REMARKS

Amendments to the Drawings:

Annotated Sheet Showing Changes

FIG. 5

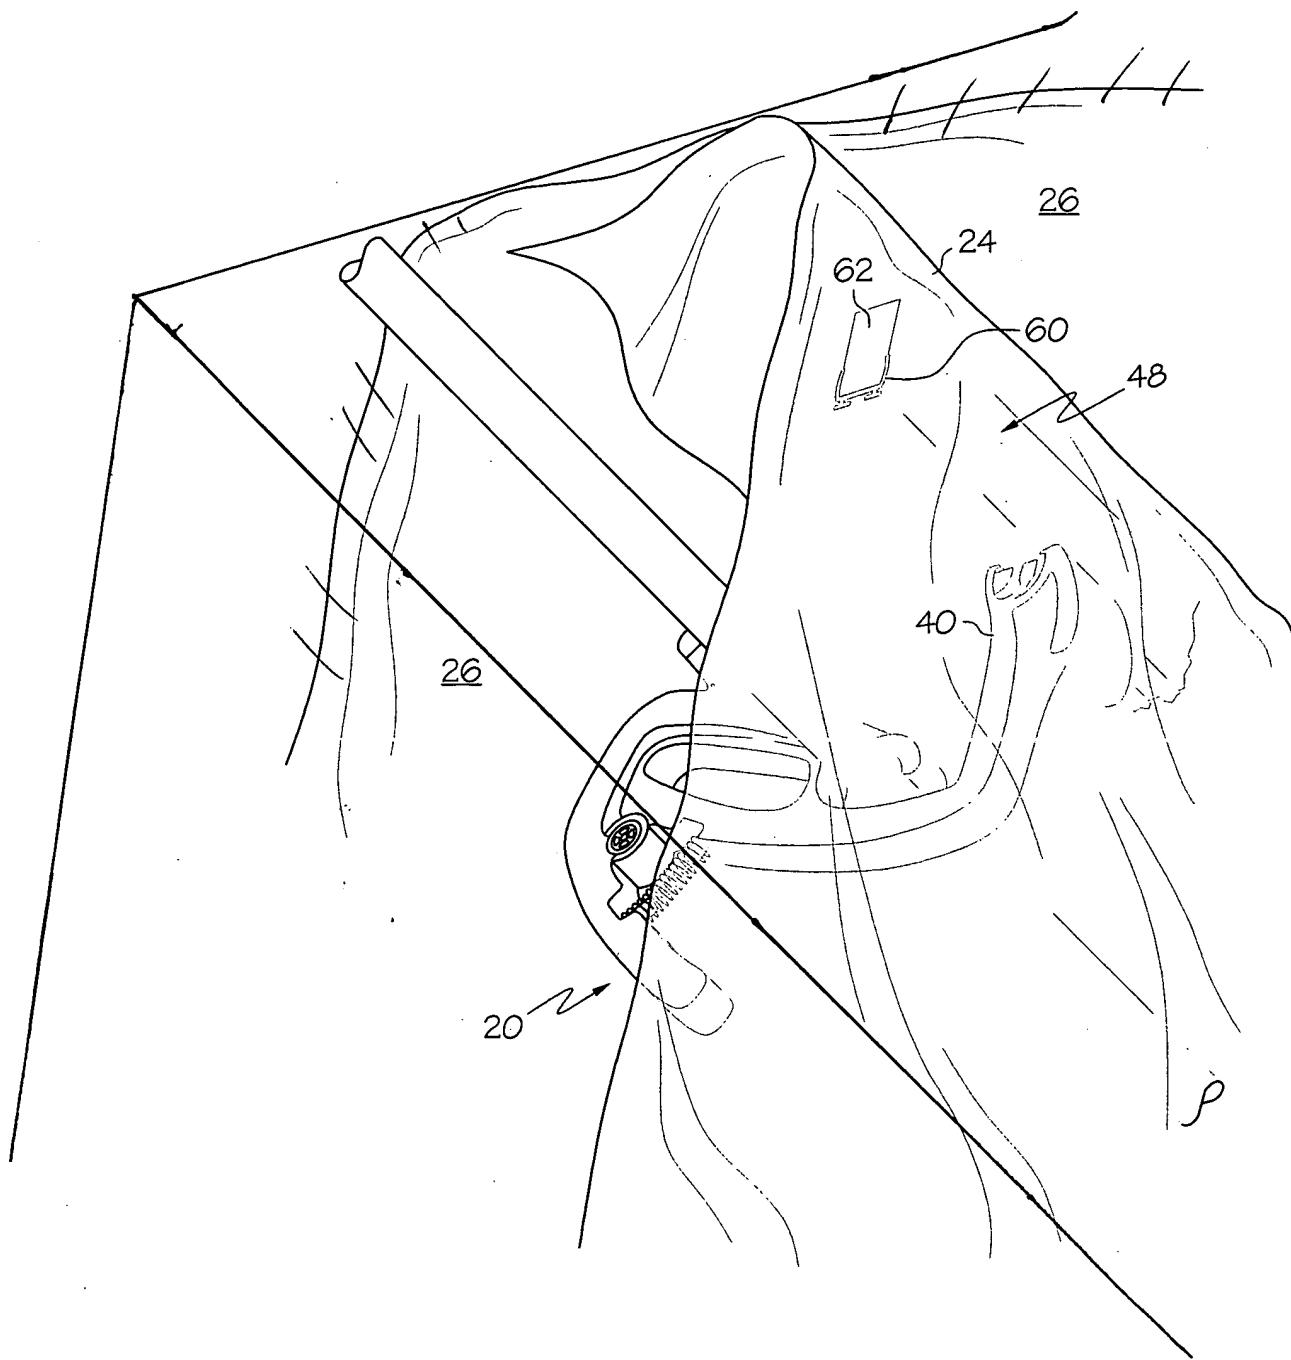
The drawings are objected to for reasons indicated in the Office Action. FIG. 5 is amended herein, such that the depiction of the wall 26 has been changed to more closely represent a wall. With regard to claims 11 and 39, new FIG. 4C is added to depict a head 48 that is integral with the mount body 30. With regard to claim 20, reference is made to FIG. 9, which provides an example of a configuration having an inwardly biased spring 44, and further to FIGs. 1-3, 5 and 11, wherein the spring is outwardly biased. With regard to claims 21 and 44, new FIGs. 12A and 12B are added to illustrate, in FIG. 12A, a biasing unit comprising a ratcheting mechanism 33, and to further illustrate, in FIG. 12B, a biasing unit comprising a hinge and a manually operated screw 35. No new matter is added. Entry of the amended and new drawings, and reconsideration and removal of the objections are respectfully requested.

The attached sheets of drawings include a sheet including changes to FIG. 5. This sheet, which includes FIG. 5, replaces the original sheet including FIG. 5. In FIG. 5, the depiction of the wall 26 has been changed to more closely represent a wall.
